SUBMITTAL IDENTIFICATION SHEET

WEBSTER UNIVERSITY ISB

123553-004 REV 1

SCIENCE EQUIPMENT ROUGH-IN
WEBSTER UNIVERSITY
WEBSTER GROVES, MO

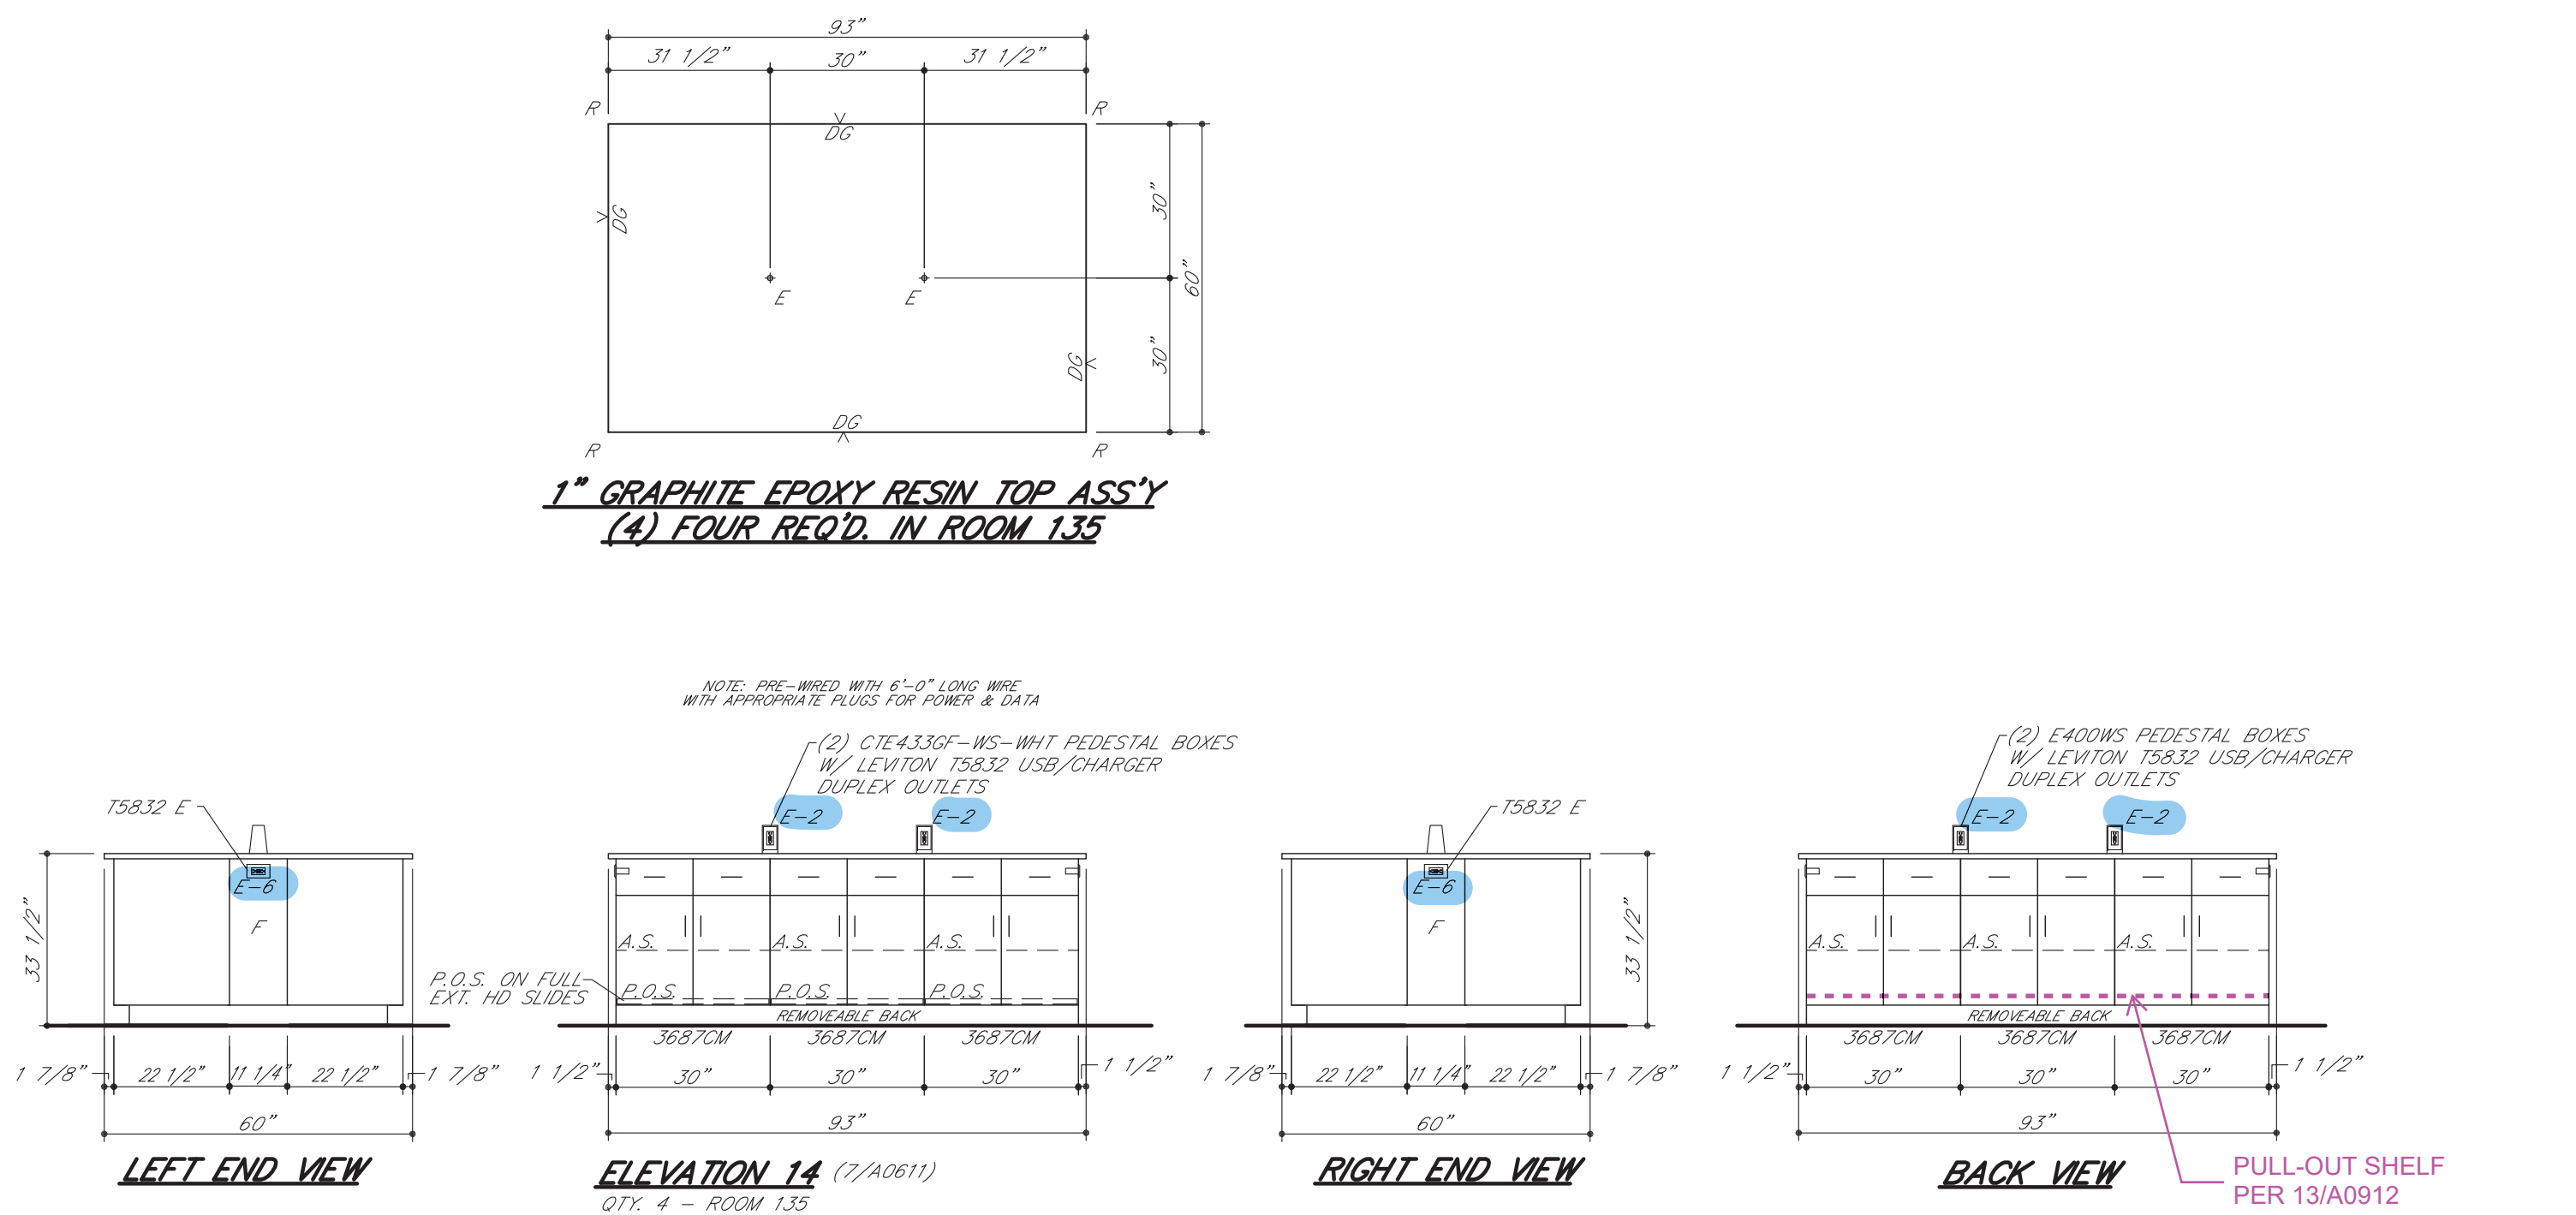
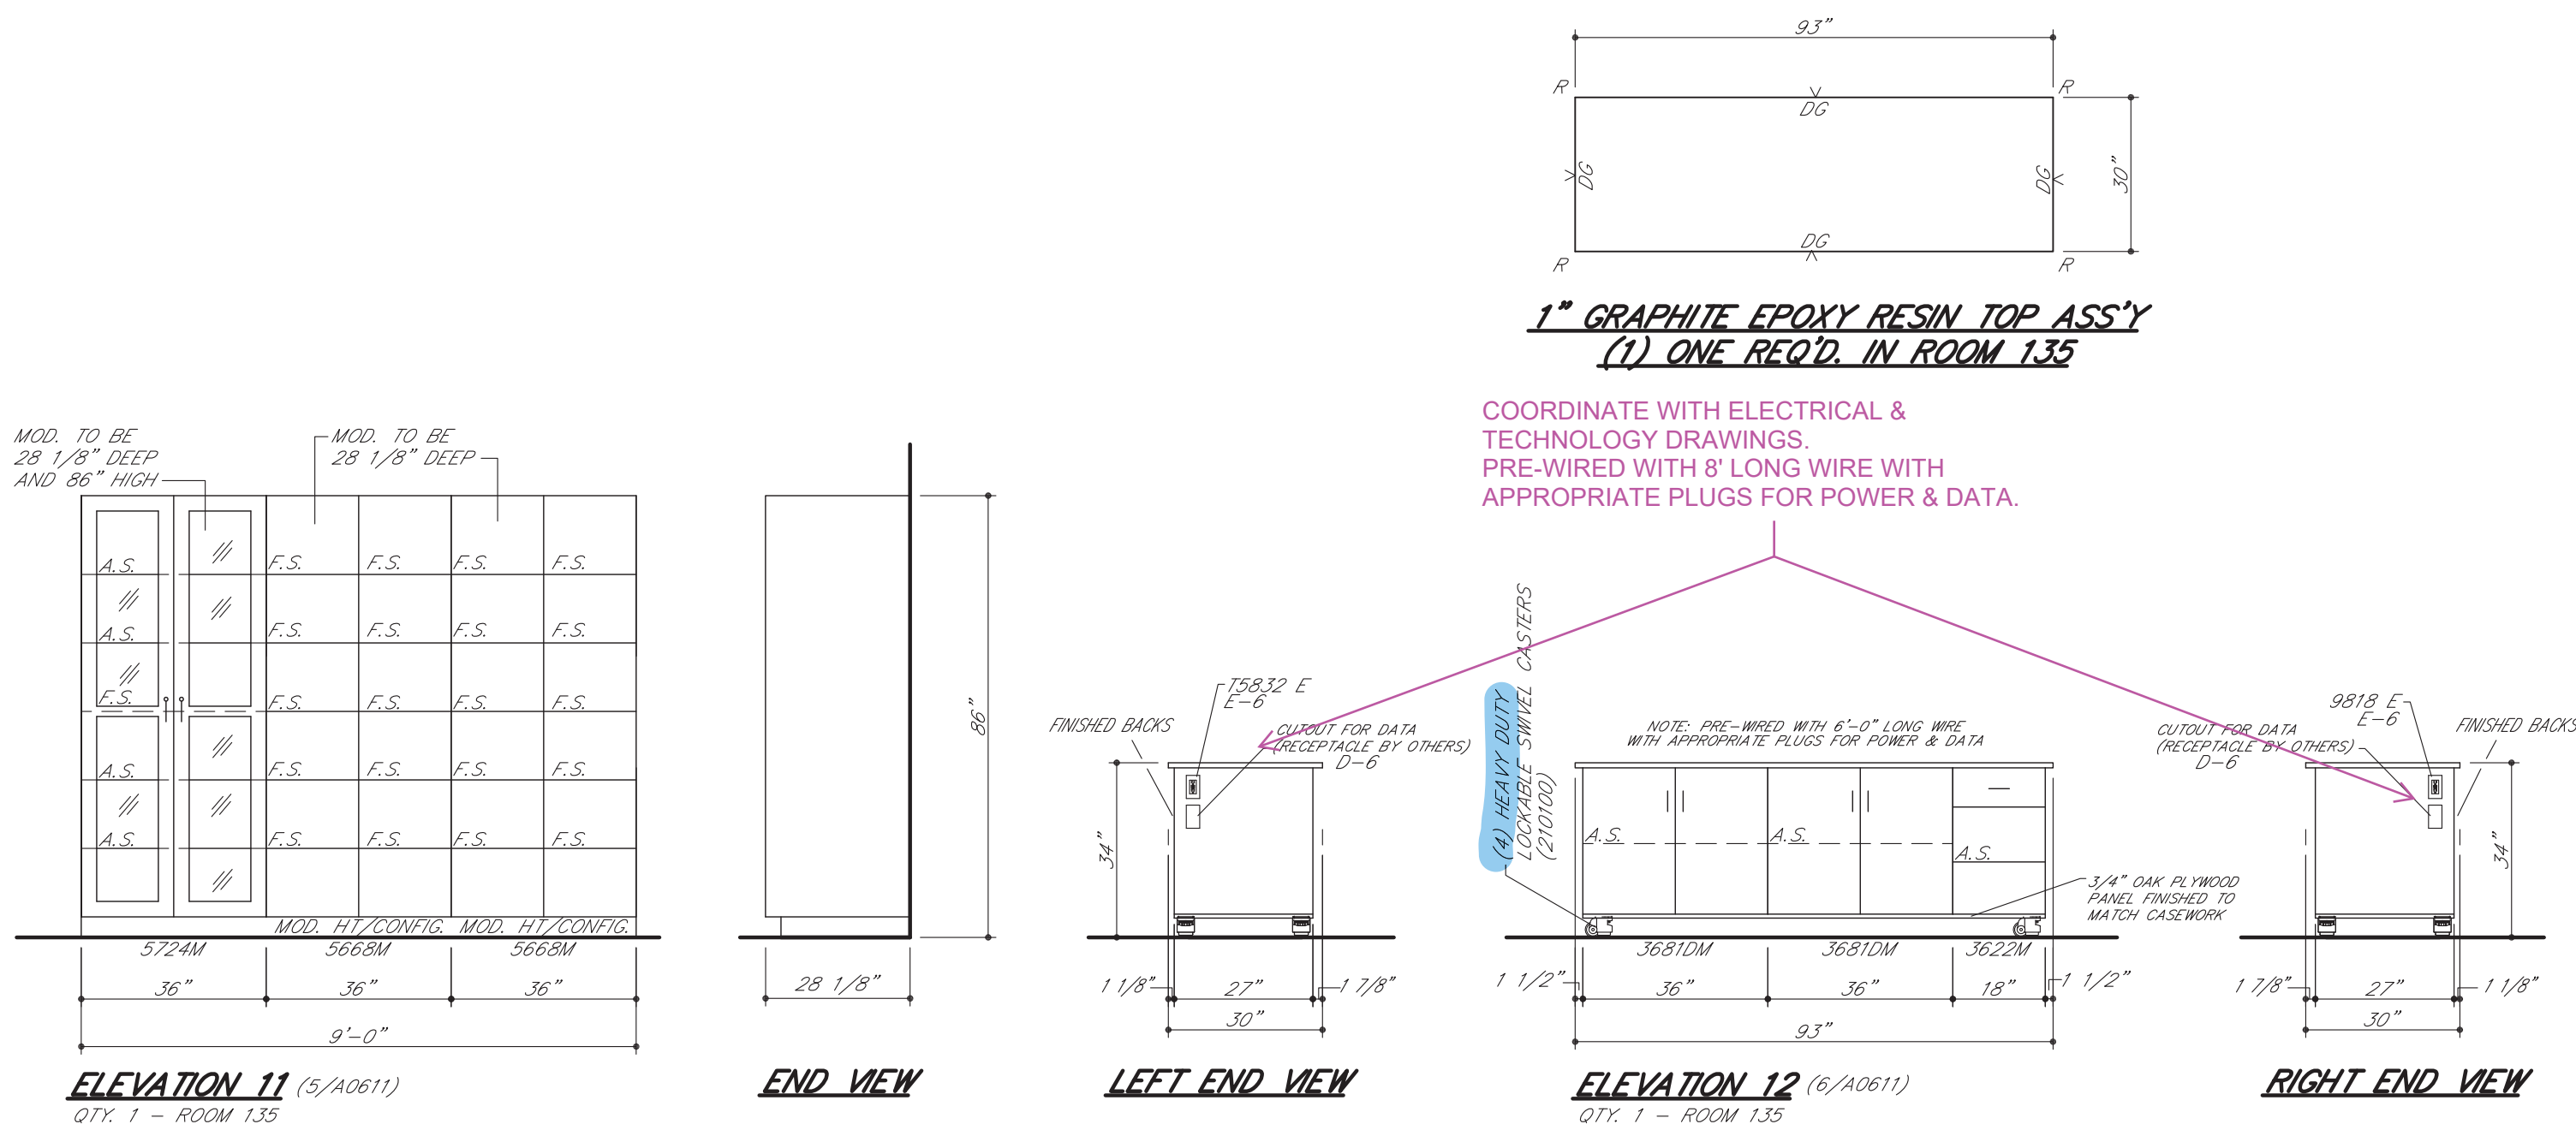
PROVIDE MCKEY ZGAVG2
AIR VENT GROMMET SET
(WARM GRAY FINISH)
(2) EACH IN THE END
CLOSURE PANEL & IN THE
BACK PANEL FOR
VENTILATION. (REQUIRES A
3 7/8" DIA HOLE.)

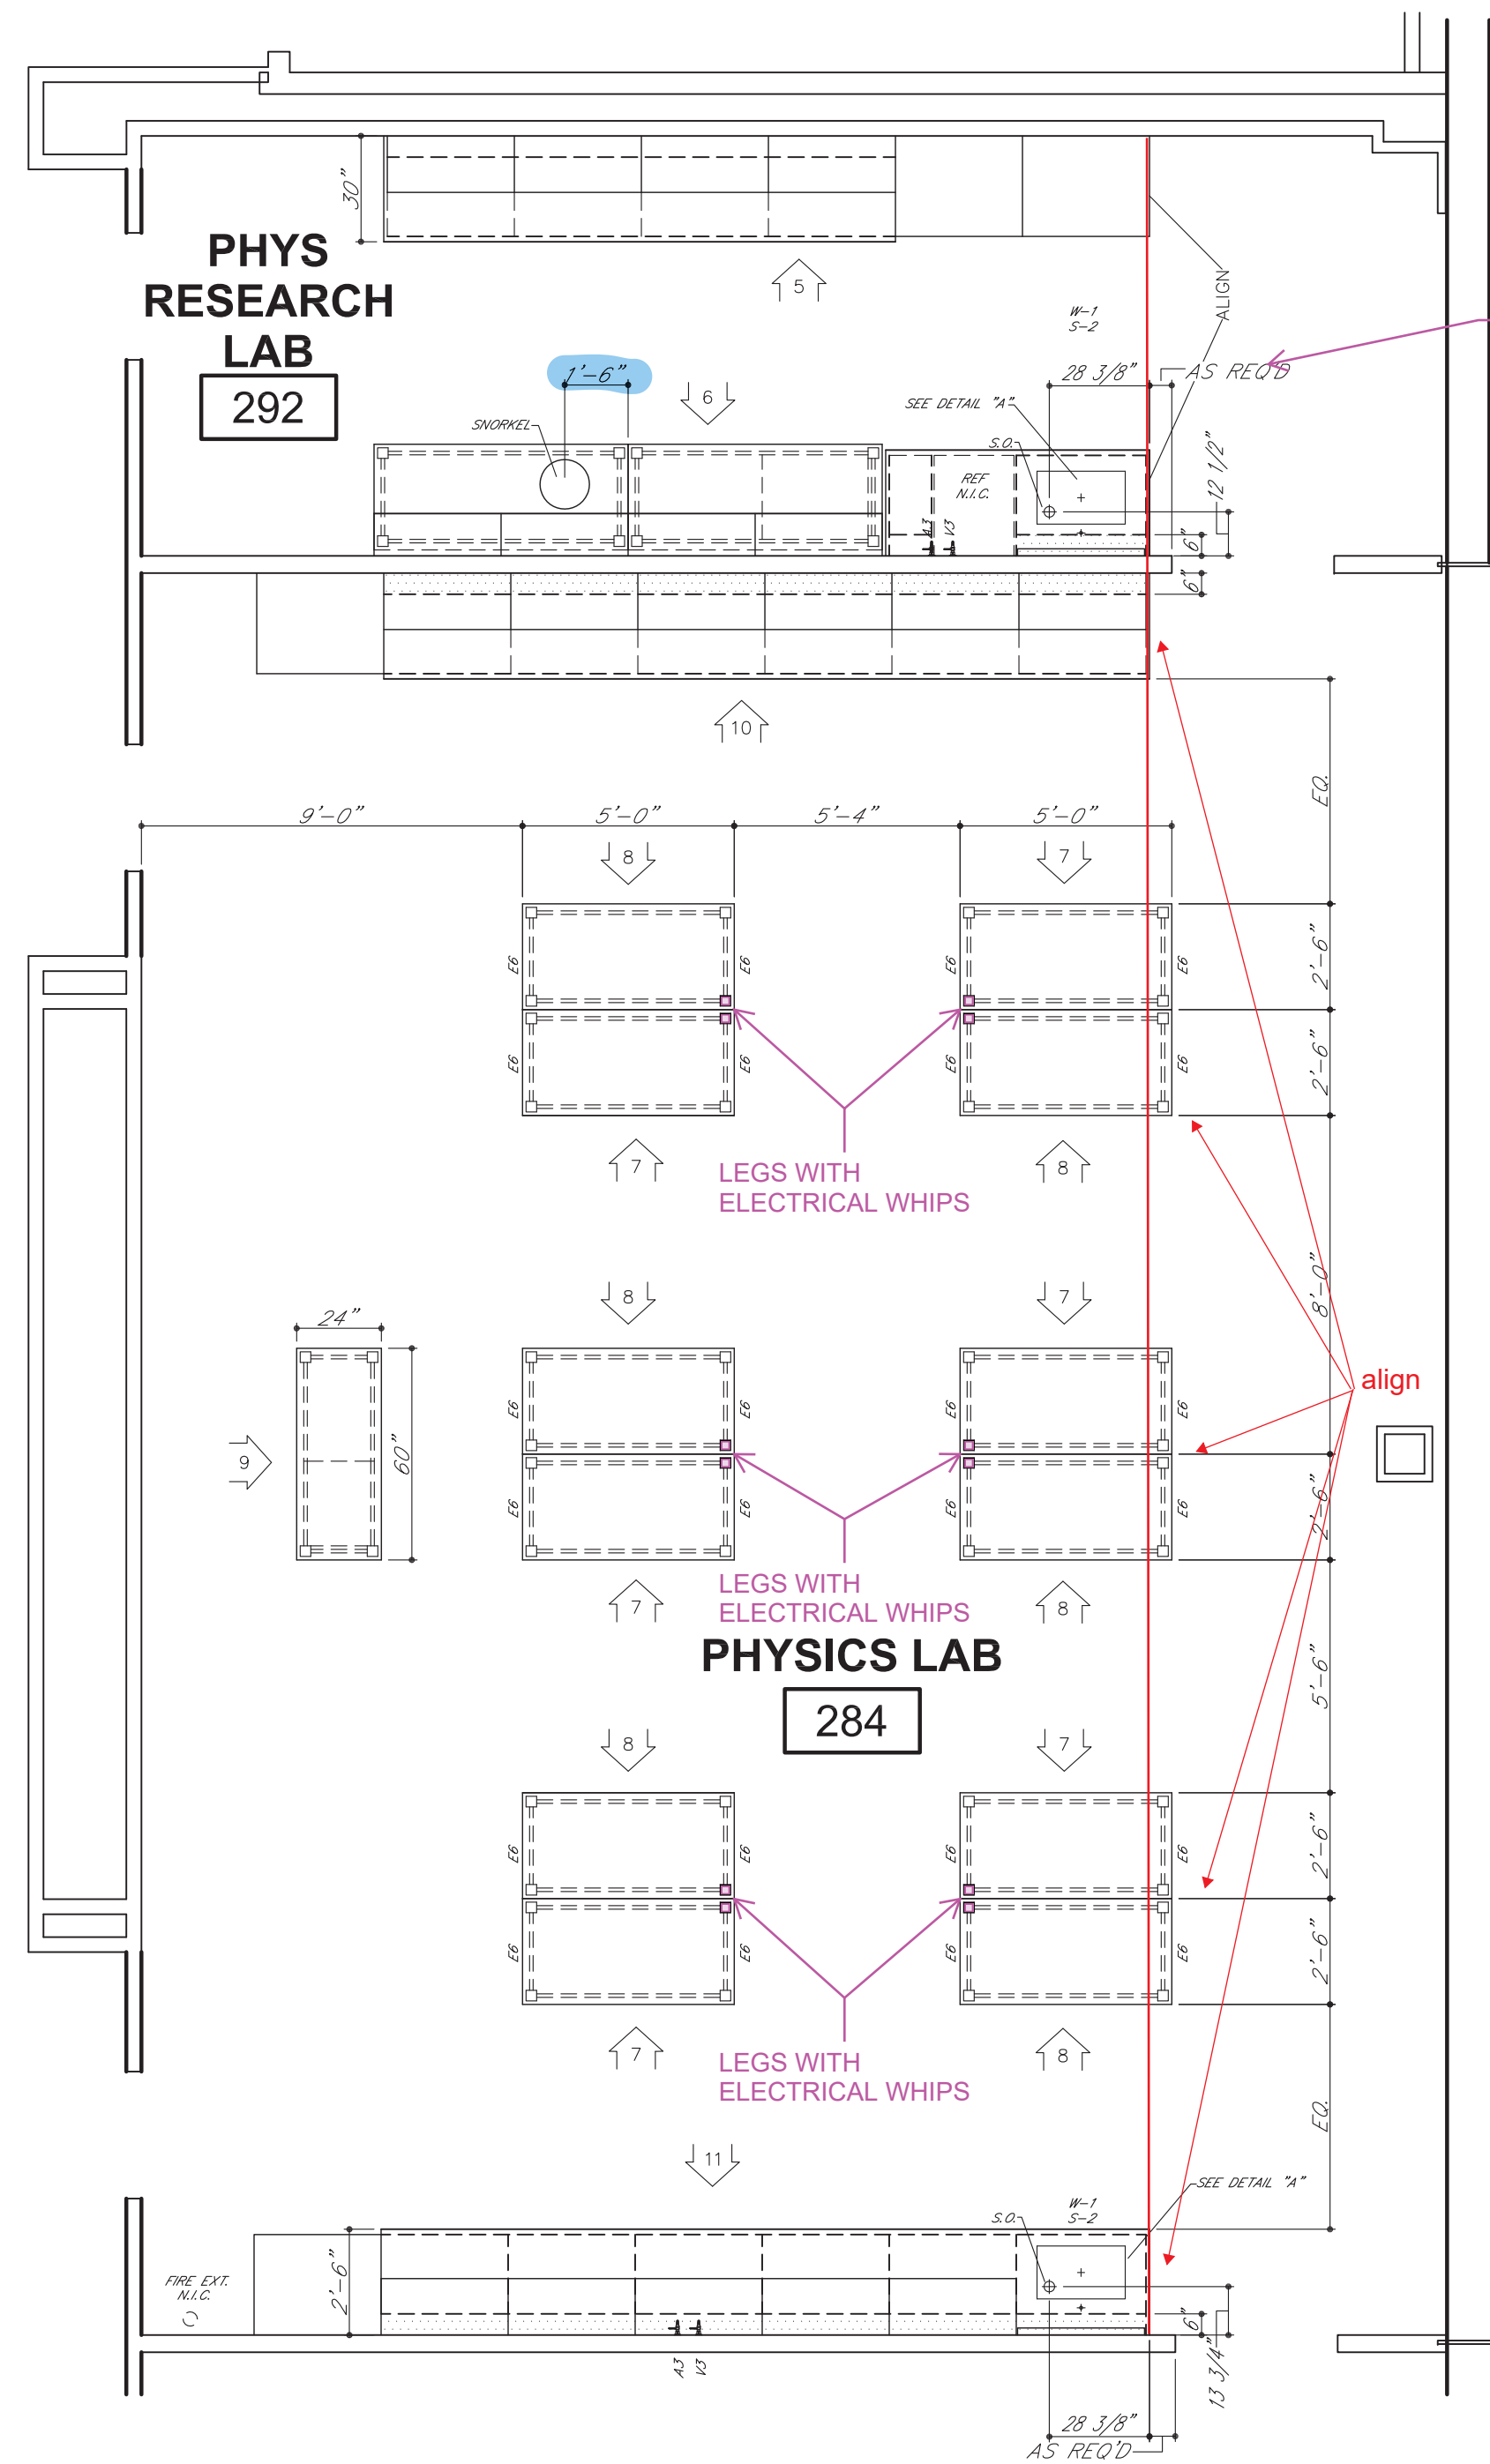
GC TO COORDINATE
WITH PLUMBING & ANY
INTERFERENCE WITH
CASEWORK

AS CLOSE TO
DOOR FRAME
AS POSSIBLE
